WETLAND IMPACT COMPARISON PLAN

FOR TOWN OF SALISBURY INLAND WETLAND REVIEW
WAKE ROBIN INN REDEVELOPMENT
104 & 106 SHARON ROAD & 53 WELLS HILL ROAD
SALISBURY, CONNECTICUT

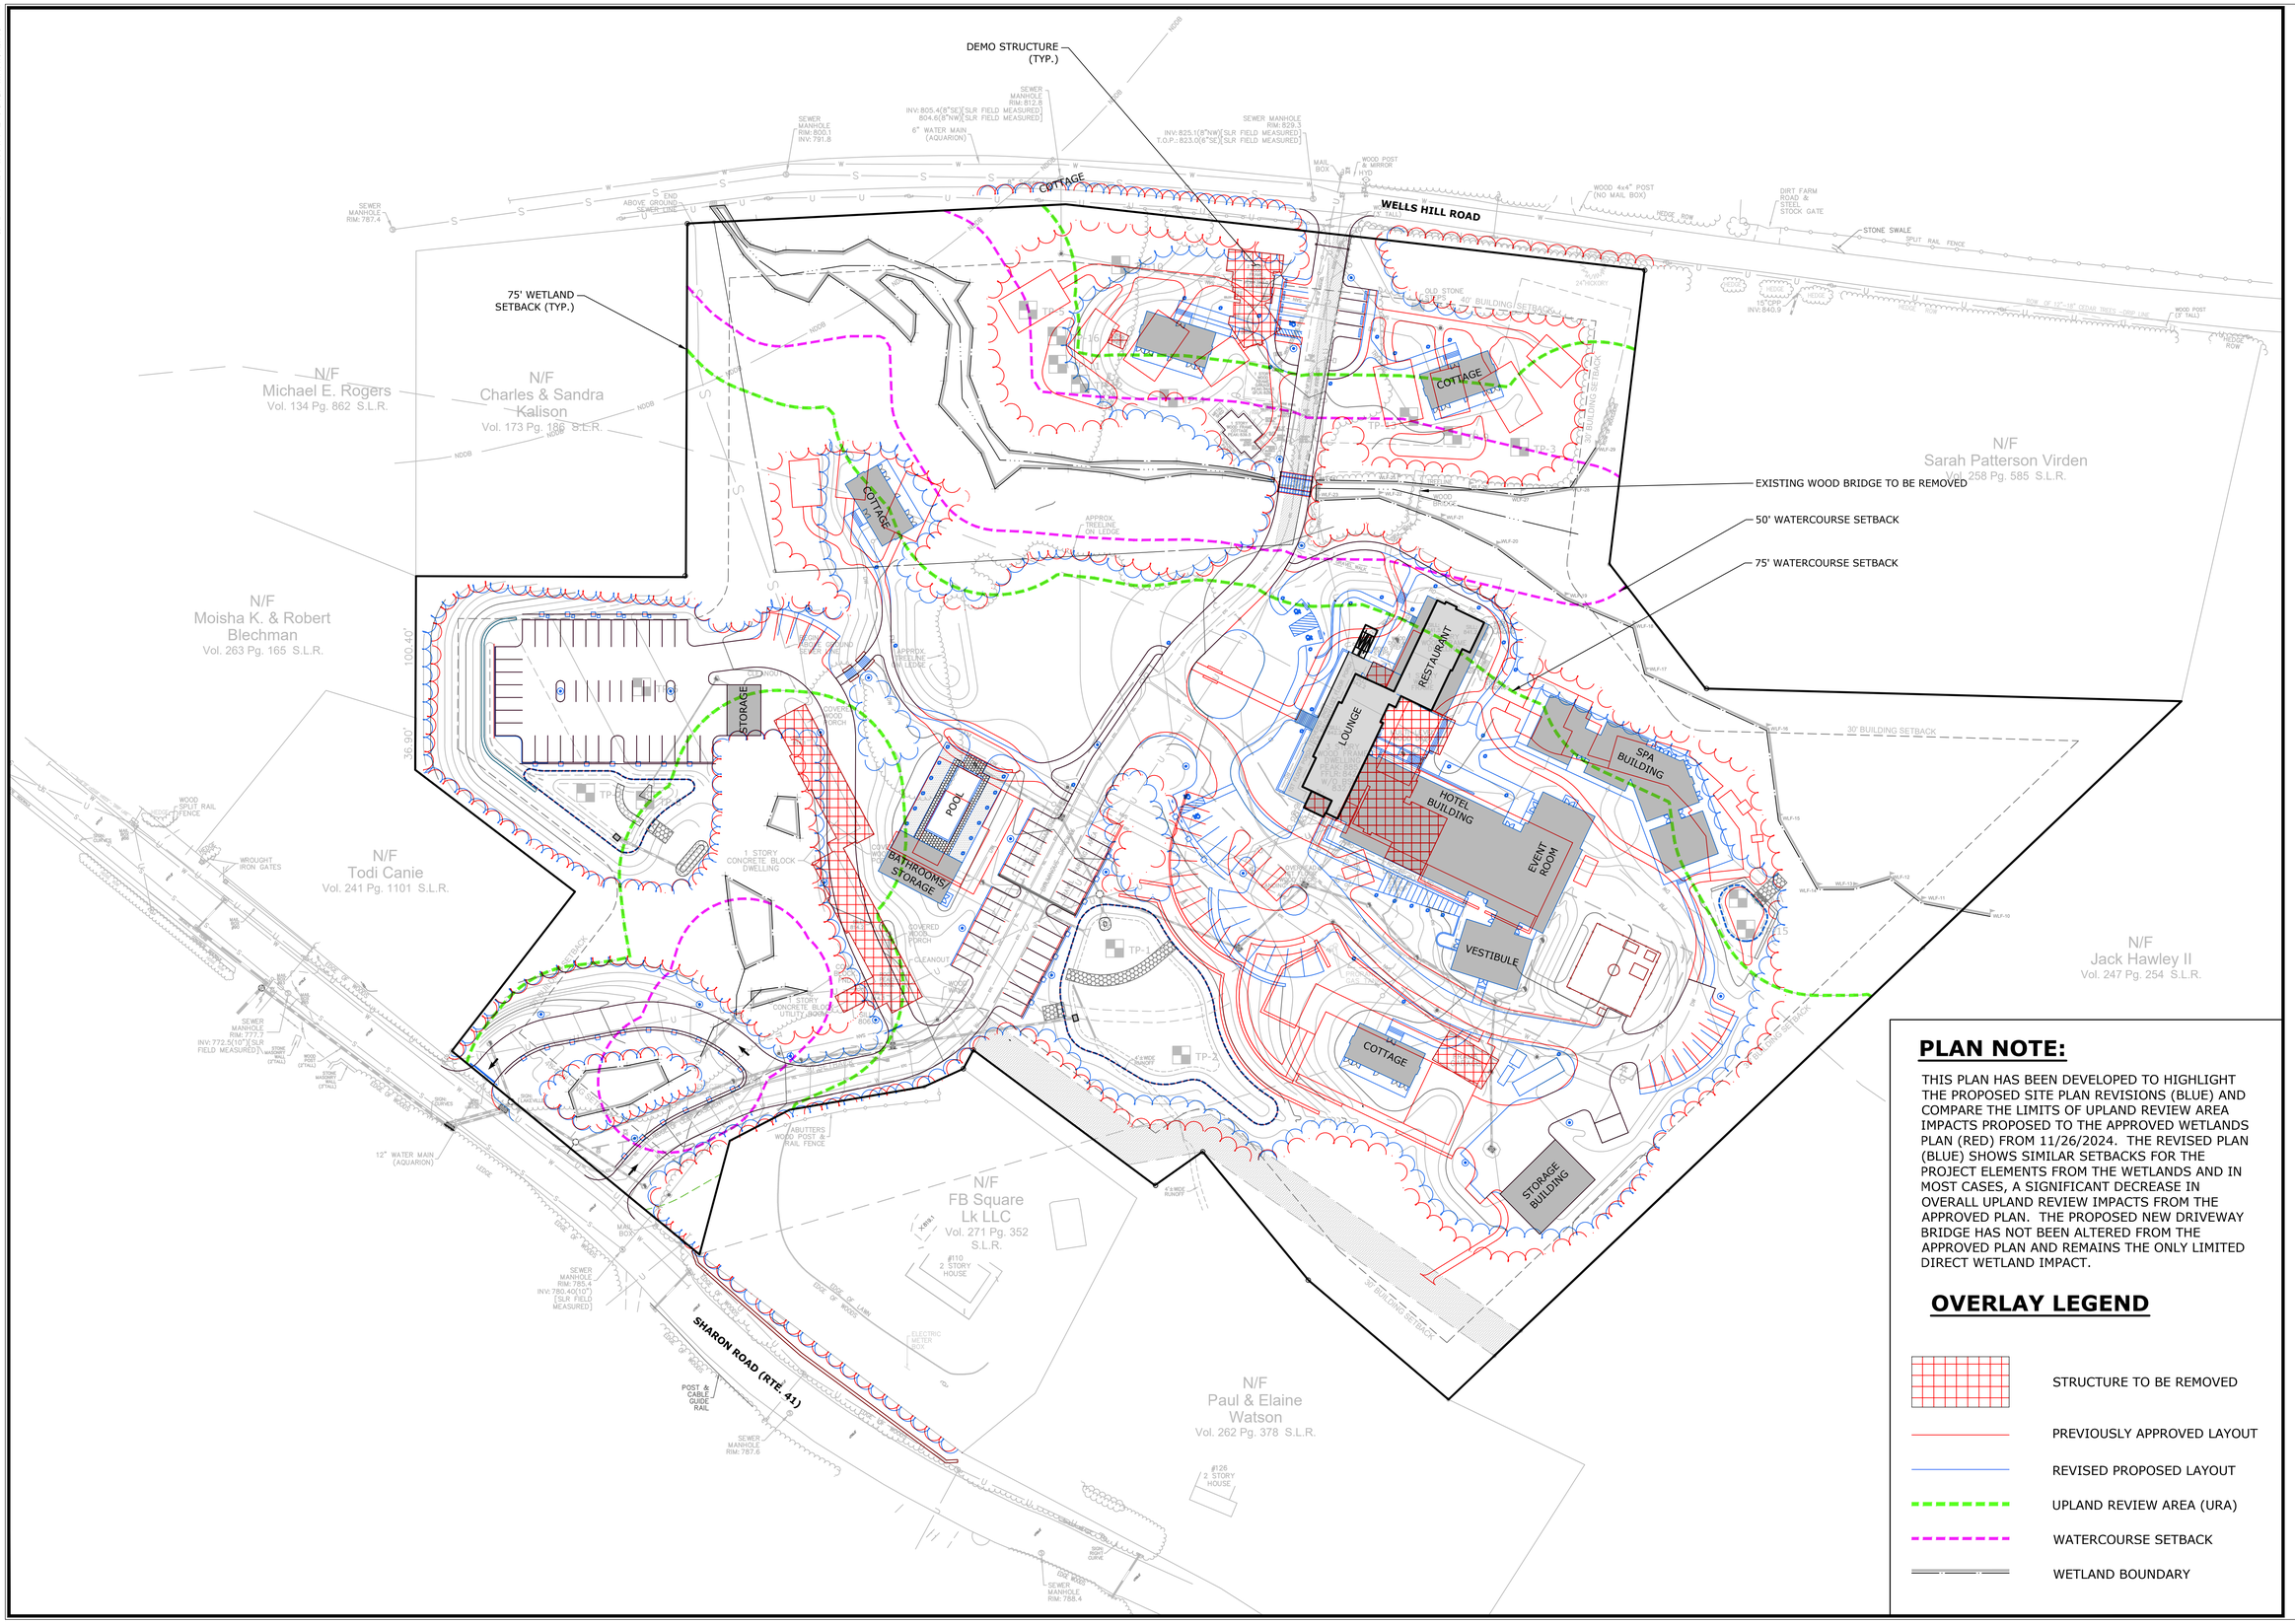
THIS PLAN HAS BEEN DEVELOPED TO HIGHLIGHT THE PROPOSED SITE PLAN REVISIONS (BLUE) AND COMPARE THE LIMITS OF UPLAND REVIEW AREA IMPACTS PROPOSED TO THE APPROVED WETLANDS PLAN (RED) FROM 11/26/2024. THE REVISED PLAN (BLUE) SHOWS SIMILAR SETBACKS FOR THE PROJECT ELEMENTS FROM THE WETLANDS AND IN MOST CASES, A SIGNIFICANT DECREASE IN OVERALL UPLAND REVIEW IMPACTS FROM THE APPROVED PLAN. THE PROPOSED NEW DRIVEWAY BRIDGE HAS NOT BEEN ALTERED FROM THE APPROVED PLAN AND REMAINS THE ONLY LIMITED DIRECT WETLAND IMPACT.
